A Public Participation

This appendix describes public involvement in the development of the 2021 PSE IRP.

2. 2021 PSE IRP PUBLIC PARTICIPATION PLAN

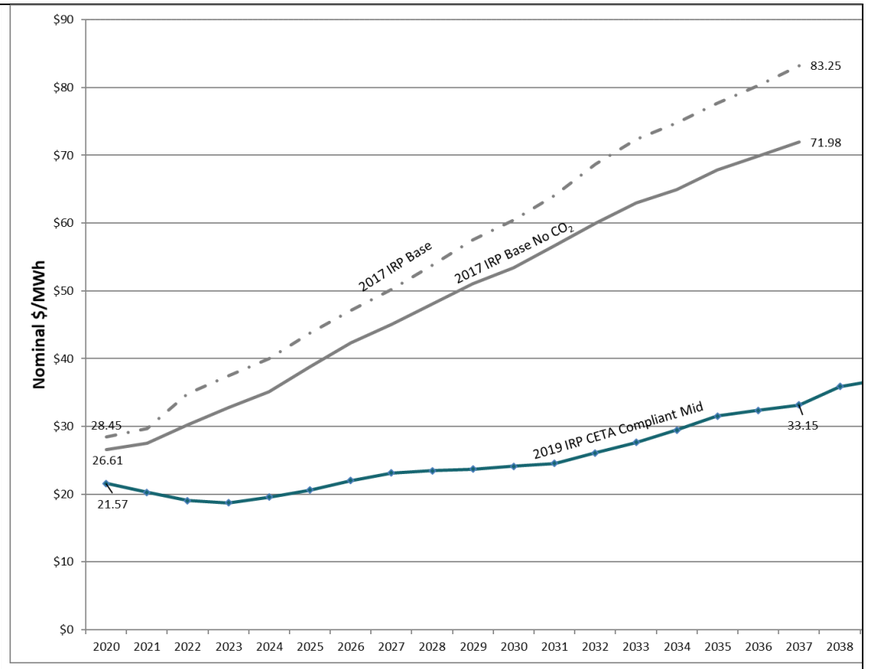
6/4/2020	James Adcock (14)	Do not reference the "2019 IRP" because there is no "2019 IRP" -- because PSE chose unilaterally with consulting stakeholders to terminate the 2019 IRP Process before it was completed.	Please see our response to your comments 5,10 & 13.
6/10/2020	Vlad Gutman-Britten, Climate Solutions	Slide 17: Why are no thermal plants built in WA? Is this CETA or some other constraint? It again reads like SCC is only applied to plants in Washington and not outside of it, which isn't in keeping with the requirements of CETA or the previous UTC acknowledgement letter. Slide 19: There are other extant policies/commitments that should be included—Xcel has committed to 100% clean by 2050, Idaho Power and Avista have both made the same commitment. A number of CO laws also matter here: Colorado utilities must consider SCC in planning and the PUC must make progress toward 90% carbon reduction by 2050. These will impact resource choices and price forecasts. Slide 20: For the utilities below 80%, these are likely to somewhat overcomply with the 2030 requirement in order to address variability in hydro. It could be worth modeling actual compliance strategies as this will yield a different mix of renewables and thus impact price forecasts. Slide 21: Assumption shouldn't be no new renewable energy investments until 2028. Considering only state-wide RE need doesn't reflect how utilities, especially investor-owned utilities, will comply. Slide 22: Would like to see the 2017 with high CO2 comparison since the 2019 does have CO2 included. Slide 29: why did price increase on this slide when on slide 27 it appears to have declined slightly? Slide 34: A little confused on the difference between the two scenarios with CA/WA; shouldn't frame CA 2045 law as a "goal"; CA 2030 requirement is RPS only, not carbon-free. Slide 42: Scenario #3 should have a higher CO2 price, going beyond what is required by law for the "high scenario." Scenario #4 appears to be a baseline comparison, and should include CETA but not the clean energy standards.	Slide 17: Given that PSE is modeling the entire region as a whole, the model assumes that there is plenty of resources in the region given normal hydro conditions and mid load. This is different than the PSE portfolio model, where PSE is accounting for transmission constraints into the PSE service territory. So even though there might be enough resources in the region, it may not be delivered to load due to transmission constraints. To reflect the social cost of carbon planning adder in PSE's portfolio model, market purchases will include a wheeling cost equivalent to the SCC adder during the capacity expansion run. Slide 19: PSE has elected not to include corporate or non-binding policies into the Power Price model due to lack of accountability of these policies and difficulty in modeling numerous policies at the balancing authority resolution. Slide 20: Thank you for the suggestion, however, PSE is unable to incorporate actual clean energy adoption strategies into the modeling process due to lack of insight into the resource acquisition strategies of each Washington utility. Therefore, PSE has elected to model either the 80% clean energy implementation required by CETA or a generic more aggressive (~90%) clean energy implementation for the 2021 IRP. Slide 21: Thank you for the suggestion, PSE is updating the assumption and will have the updated targets for the July 1 consultation update. Slide 22: Below is the updated chart which includes the 2017 IRP Base power price:

Slide 29: Slide 27 shows the annual, nominal power price for the 2019 IRP process and draft 2021 IRP power price. Slide 29 shows the levelized power price over the timeframe for each IRP process, which incorporates the time value of money (net present value). Each slide is an NPV over different time periods which is why they are slightly different.

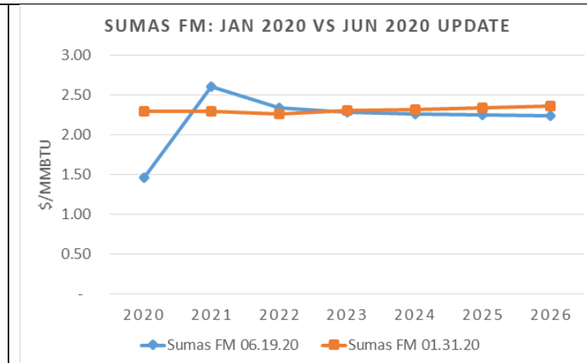
a. Staff requests more clarification on how PSE is modeling California renewables; it is not clear regarding the ramp between 60% and 100%. Will it be at ~80 percent in 2030? b. What C02 price is applied for CA AB32 and BC? 7) Other questions regarding PSE's social cost of greenhouse gas emissions modeling: a. PSE explains the methodology will be discussed at a later July 21 webinar. Does PSE plan to model SCC applied to thermal power imports into WA? b. It is staff's understanding in Aurora a "wheeling adder" can be added for imports into California, which is then used to capture the cost of carbon imports. Is this approach also appropriate for Washington to model the social cost adder of greenhouse gas emissions for imports?	*(b) For the purposes of this subsection (3):* *(i) Gas consisting largely of methane and other hydrocarbons derived from the decomposition of organic material in landfills, wastewater treatment facilities, and anaerobic digesters must be considered a non-emitting resource; and* *(ii) Qualified biomass energy must be considered a non-emitting resource."* ***Section 14, Page 33*** The legislation explicitly instructs utilities to use the SCC as a cost adder when evaluating conservation efforts, developing IRPs and CEAPs, and evaluating resources options. PSE understands this "cost adder" to mean that the SCC is included in planning decisions, but not in the actual cost and dispatch of any resource that it is applied to. 3.a. Thank you for your feedback, PSE will be using Scenario 1 for the clean energy implementation. b. Thank you for your feedback on the scenarios. PSE is reviewing through all the suggestions and getting in contact with some stakeholders for further discussion. PSE will have the final list of scenarios for the consultation update. 4. PSE has contacted the Northwest Power and Conservation Council to request for the 7th power plan mid-term update. There will be an update in the consultation update on whether we were able to get the demand forecast and if it is usable for the 2021 IRP. 5. The Wood Mackenzie gas price forecast is from fall 2019. This is the most recent forecast for Wood Mackenzie, the update forecast will not be ready for several weeks. However, PSE can update the foreword marks through 2026. The updated foreword marks (blue line) is the 3-month average ending June 30, 2020. As seen in the chart, the 2020 costs are much lower than the January 31 estimate and then the 2021 costs are higher during the current economic recovery. However the prices return back to January estimate by 2022 and continue to match closely through 2026. Since the time horizon for the 2021 IRP starts in 2022, this update will not have much of an impact.

a. The California SB100 requires 60% renewable resources by 2030, so PSE is modeling 60% by 2030 and then ramping into 100% by 2045.

Gas price forecast

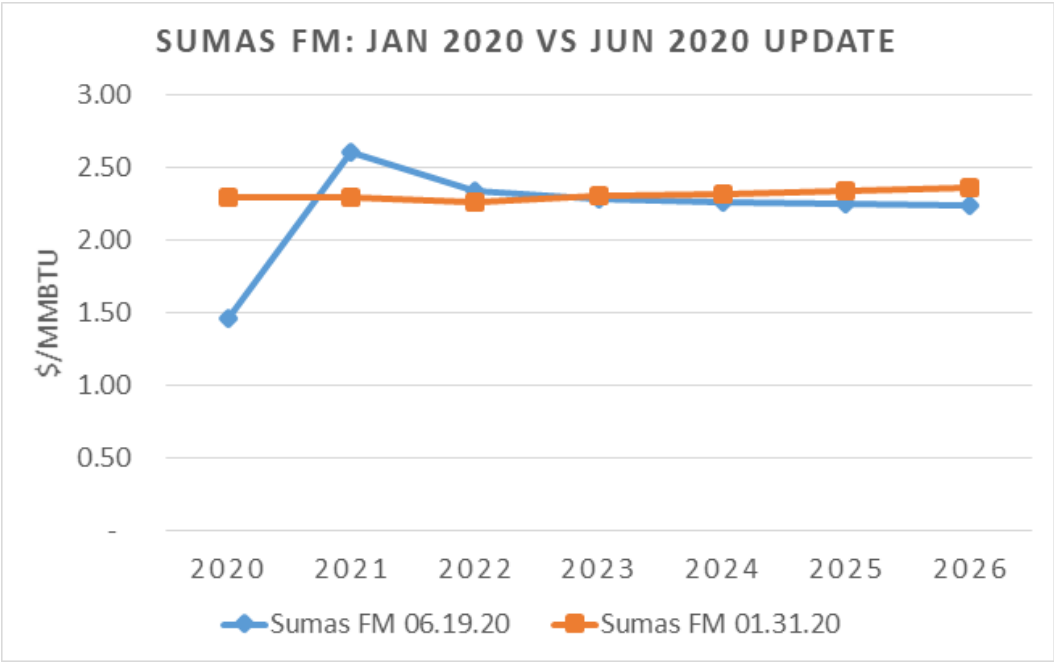
PSE received feedback from Kathi Scanlan, Washington Utilities and Transportation Commission (WUTC) Staff, requesting the use of an updated gas price forecast to reflect the socioeconomic changes of the COVID-19 pandemic. The PSE gas price forecast is an amalgam of two price forecasts incorporating forward marks for the short-term forecast (5 years in the future) and a Wood Mackenzie forecast for the long-term forecast (greater than 5 years into the future). PSE has updated the forward marks portion of the forecast as reflected on the chart below. The chart compares the January 2020 and June 2020 gas forward marks forecast for the Sumas hub. The chart shows a significant drop in prices in year 2020 and a slight increase in prices for year 2021, and a very similar projection in years 2022 through 2026. Given the 2021 IRP timeframe extends from 2022 to 2045, PSE does not anticipate the change in forward marks prices to have a meaningful impact on the power price forecast.

PSE has contacted Wood Mackenzie for an updated long-term gas price forecast and was informed the forecast would be released in the coming weeks. PSE will examine the magnitude of change of the updated long-term gas price forecast and, if deemed significant, incorporate the new forecast into the power price model. Further details will be provided upon receipt and analysis of the new long-term gas price forecast.

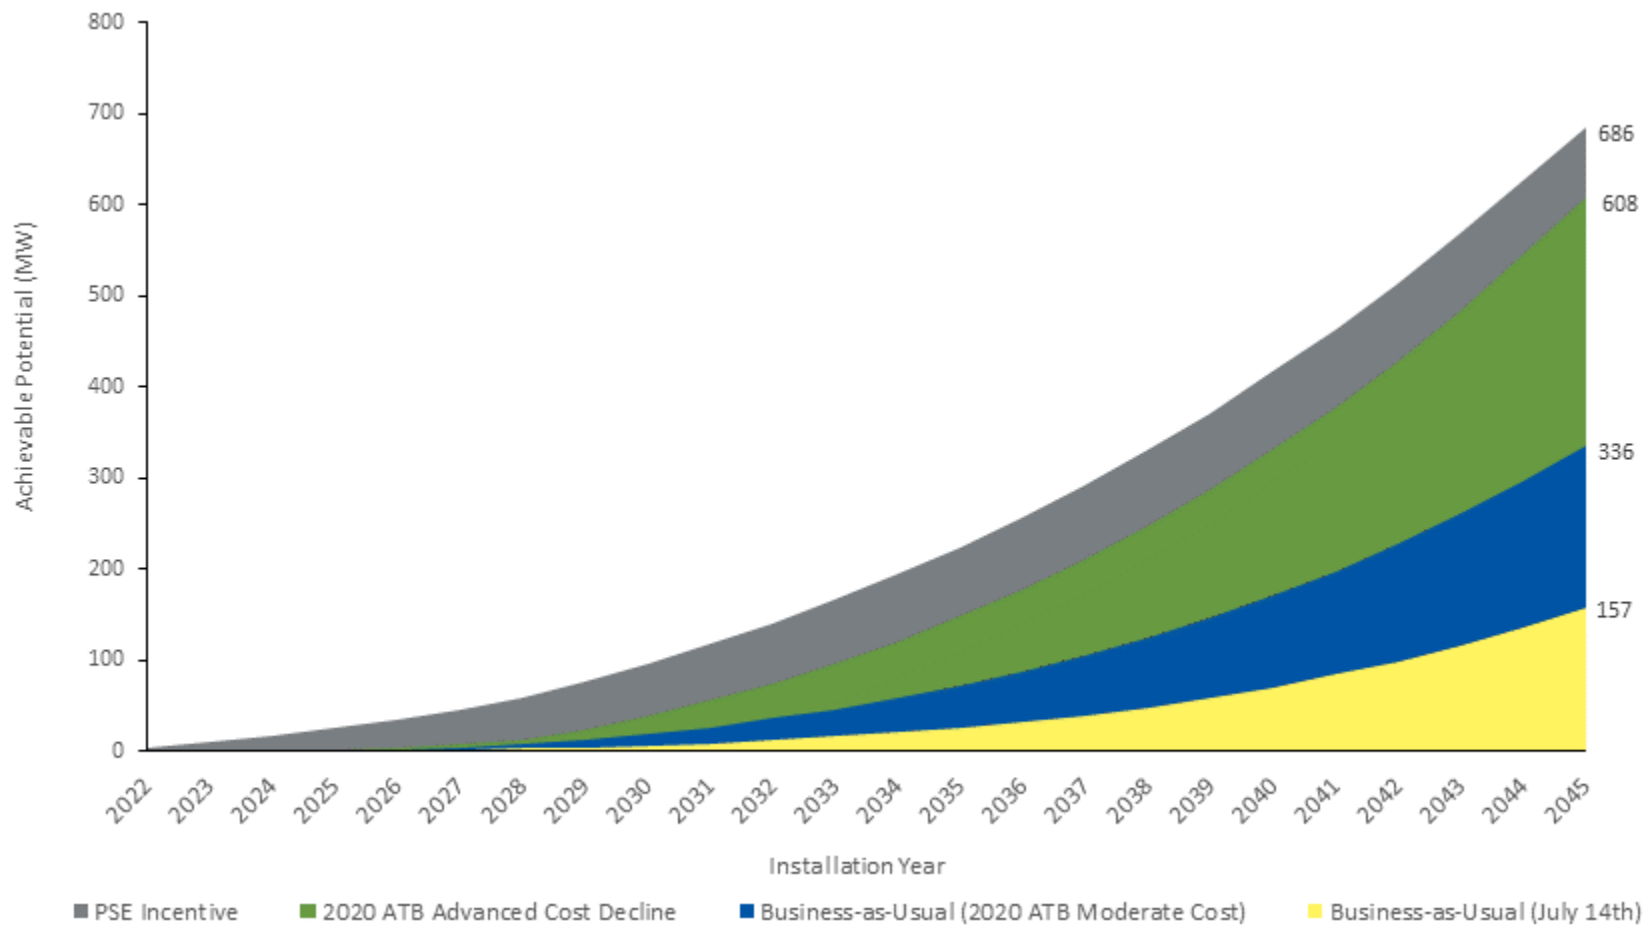
Based on these results and feedback from the stakeholders, PSE will:

1. Update the business as usual (BAU) case to the 2020 ATB *Moderate* Cost forecast, and
2. Replace the PSE incentive sensitivity with the 2020 ATB *Advanced* Cost decline as the sensitivity

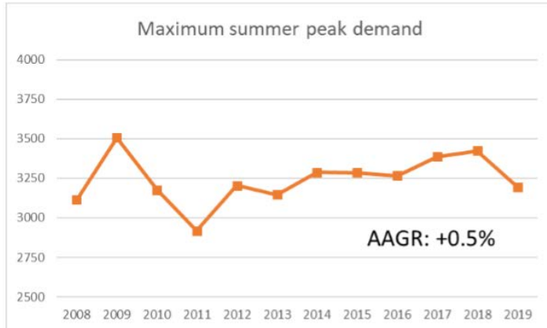
8/28/20	Don Marsh, CENSE	[Opportunity for improvement 2] Although PSE included a table showing historical summer peak demand, the presentation includes no forecast for summer peaks. It doesn't even include a graph of historical summer peak demand, so I created the graph from PSE's data [see Don's letter OR Michele to insert picture]:	The IRP analysis optimizes generation resources to meet the maximum capacity need. For PSE the customer load has historically peaked in the winter. However, PSE will consider providing stakeholders the historical and forecasted electric summer peak information.

The graph shows a very gradual rise in summer peak demand, averaging about 0.5% per year. The peak in 2018 was almost as high as the highest peak in 2009, although the peak temperature in 2018 was eight degrees cooler, so it appears that peaks are gradually increasing.	
8/28/20	Don Marsh, CENSE	[Opportunity for improvement 3] We are puzzled why PSE is issuing RFPs for winter demand response, but no corresponding RFP for summer demand response. Summer peaks are increasing, and winter peaks are not. Obviously, the summer peaks are about 25% lower than winter peaks, but we understand that PSE is concerned about summer reliability. Does PSE believe that summer demand response is not needed or not as feasible as winter demand response?	The RFP is targeting specific areas that have a winter morning peak capacity need. Future RFPs will have different objectives.

Temperature Sensitivities, planning standard and recent peak load data

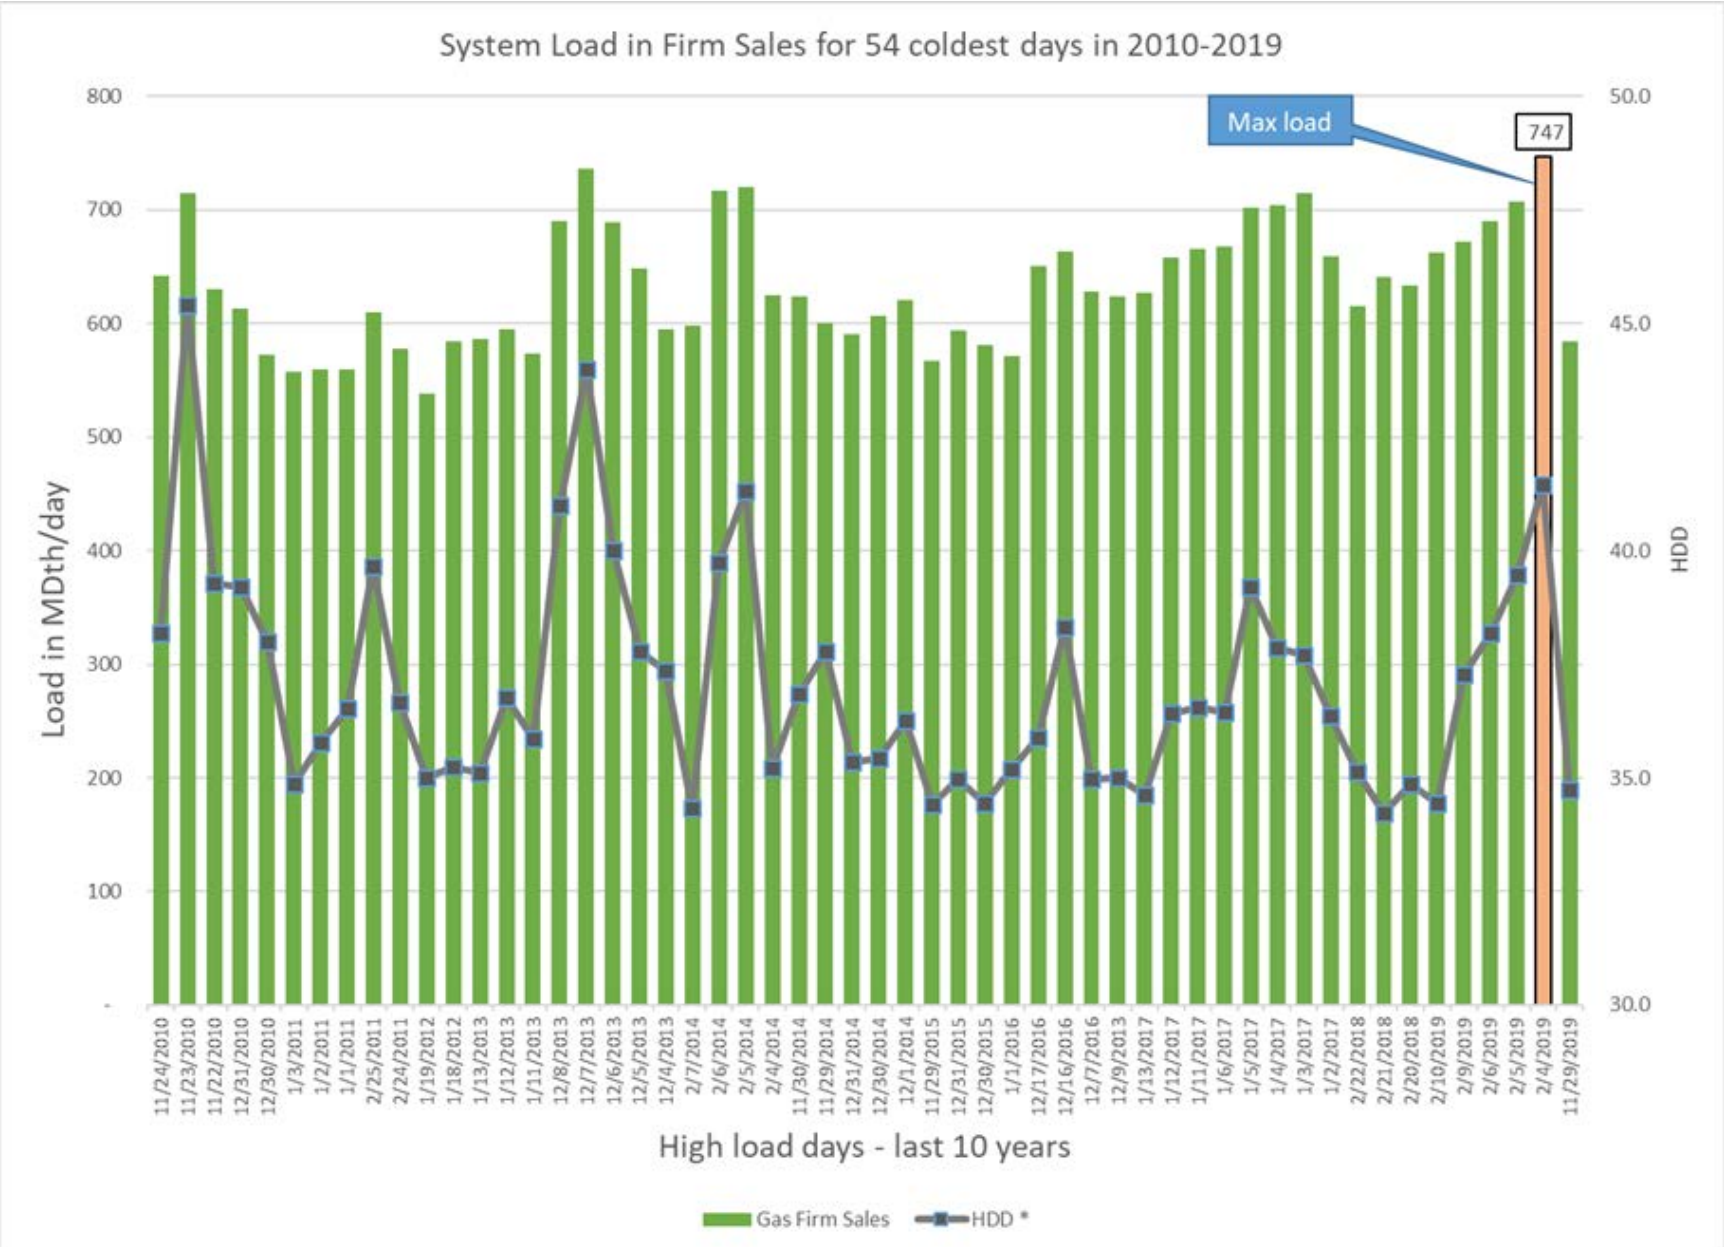
PSE received a request to share the most recent 10 years of peak day load experienced by the gas system. The graph below includes the highest load days over the last 10 years along with the gas system load and associated HDD.

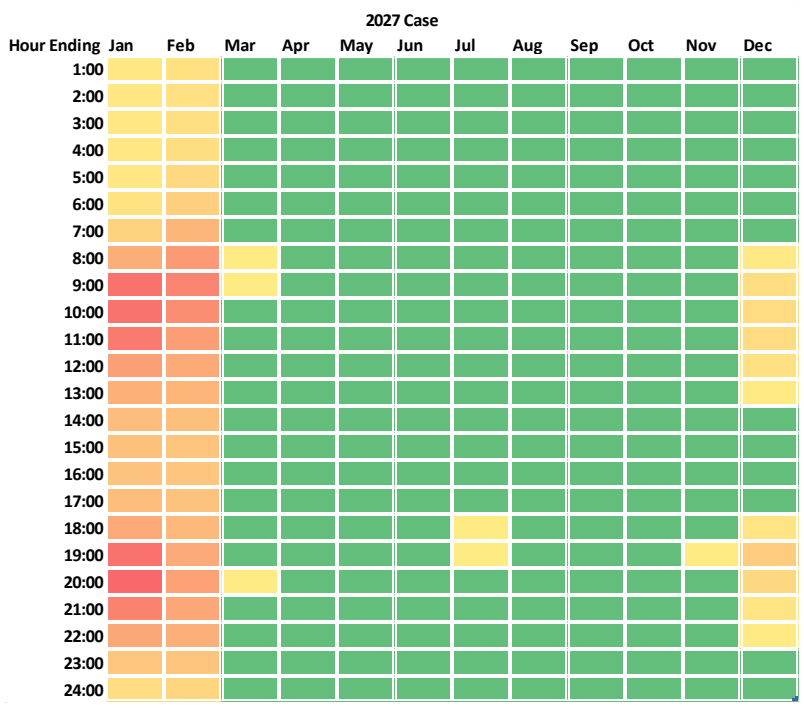
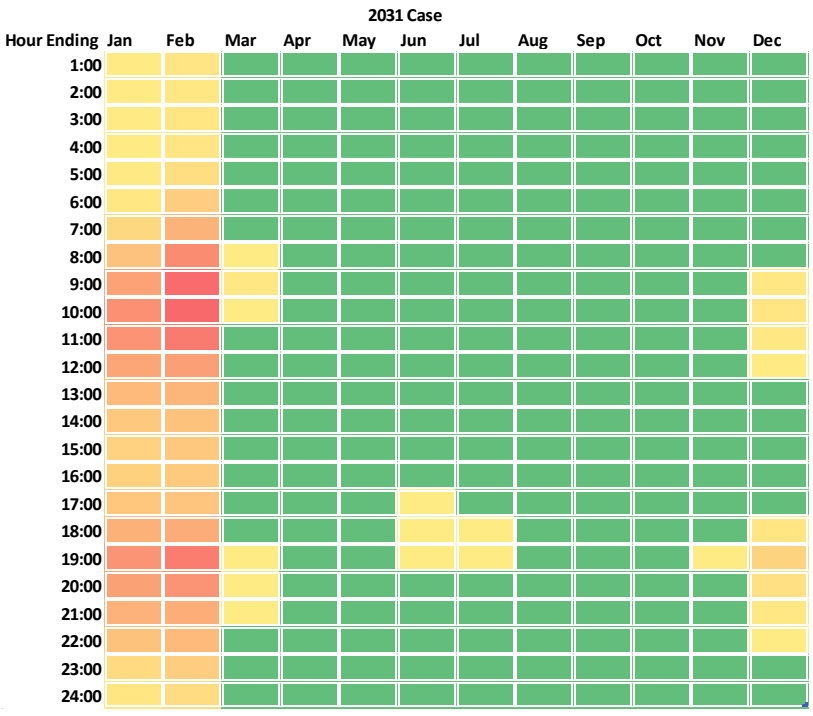
Katie Ware (Renewable Northwest) had also requested a 12x24 of the loss of load probability as part of this feedback cycle. Given the methodology of the Resource Adequacy Model, PSE is not able to produce hour by hour probabilities, so instead these plots represent a relative heat map of the number hours of lost load binned by month and hour of day.
